**Mandell Residence Site**

26 Shadyside Avenue, Nyack 71.05/1/8; R-22 zoning district

## Submission Reviewed:

Architectural plans as prepared by Kathleen Rifkin, Architect dated July 2018 and site plans as prepared by Atzl, Nasher & Zigler, P.C. Last revised 2-10-2020.

# SITE DEVELOPMENT PLAN

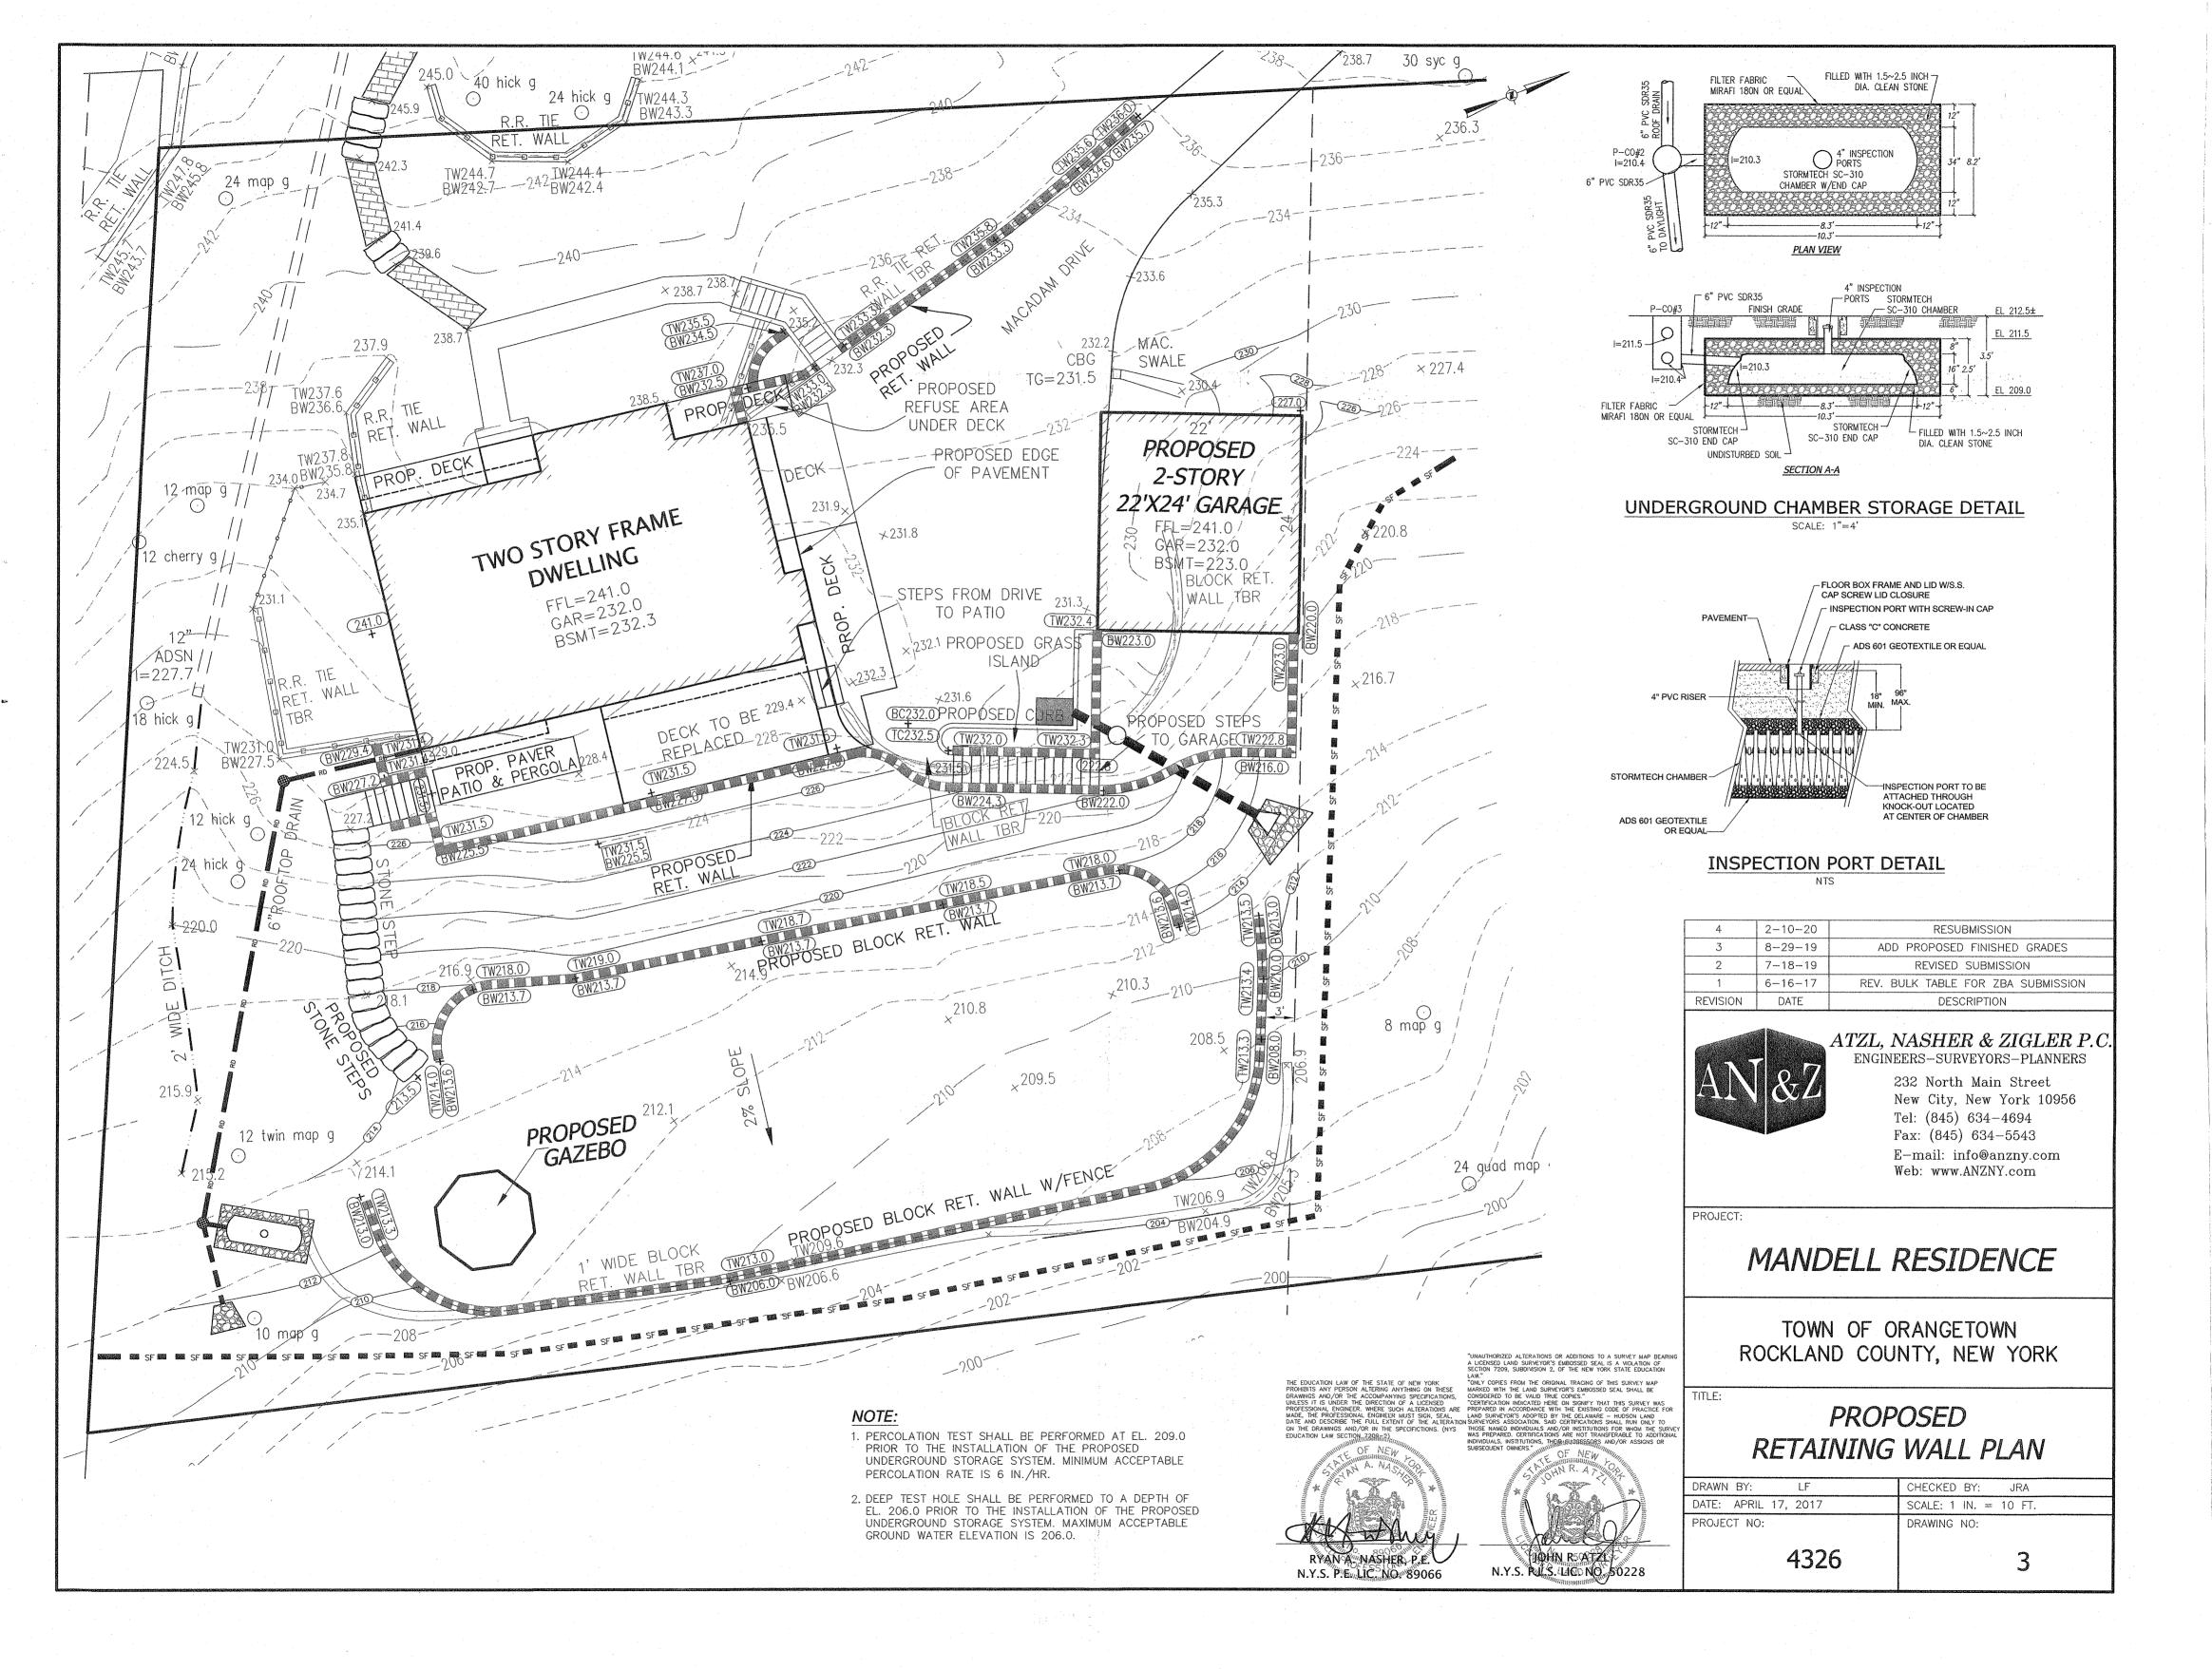
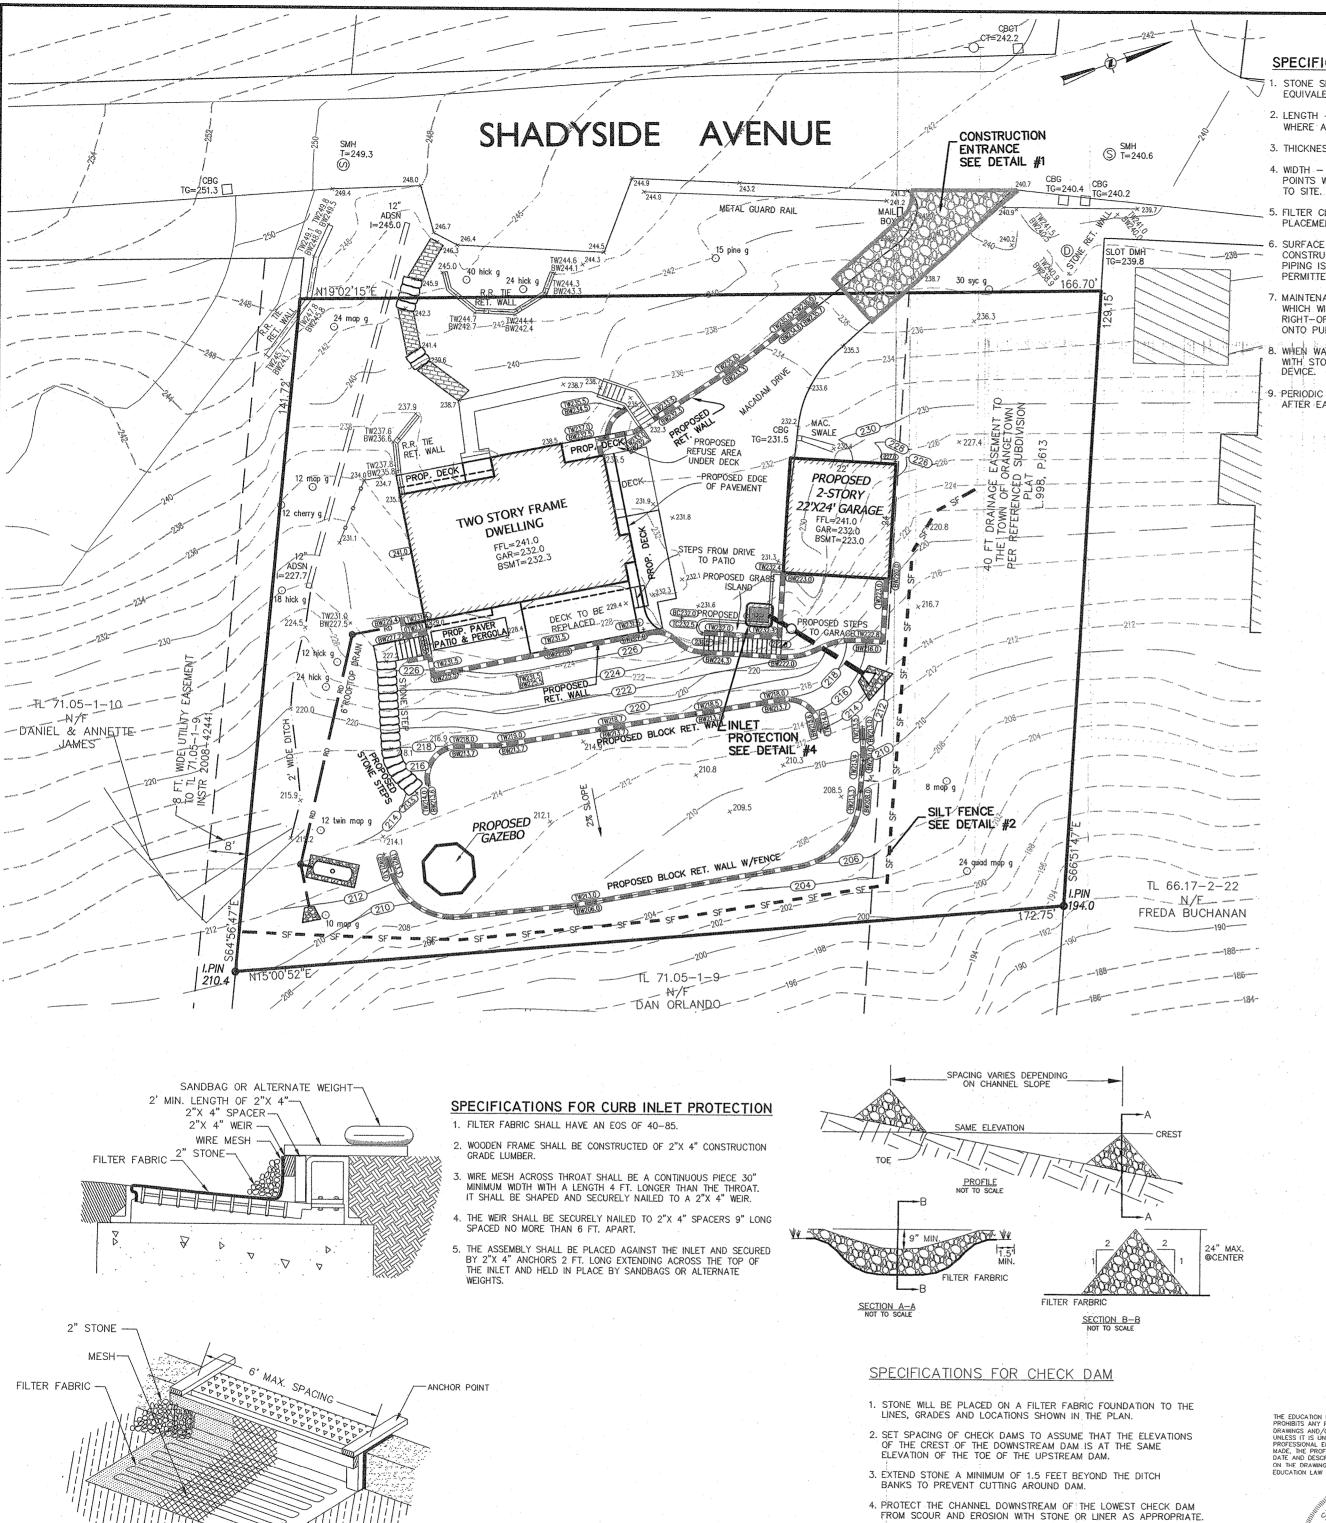
This project originally received ZBA approval on September 6, 2017, ZBA #17-61. The applicant has made application to the ZBA as the approval has expired. The previous ZBA approval granted a 31.1' and 35' front yard setback and a 24.2' side yard setback. The previous plans did not indicate the setbacks to the proposed front decks. The current site plan correctly indicates the setbacks.

Column 8, Front Yard required is 40', with existing 31.1' to main dwelling and 29' proposed to the front deck and 35' proposed to new garage.

Column 9, Side Yard required is 25', with 23.8' existing and 22' proposed to covered deck.

Your site plan indicates a "future 2 story garage", future gazebo and future retaining walls. Is this the intent?

If so, does your client realize that they will have to come in for separate permits for each of the structures with complete construction plans?
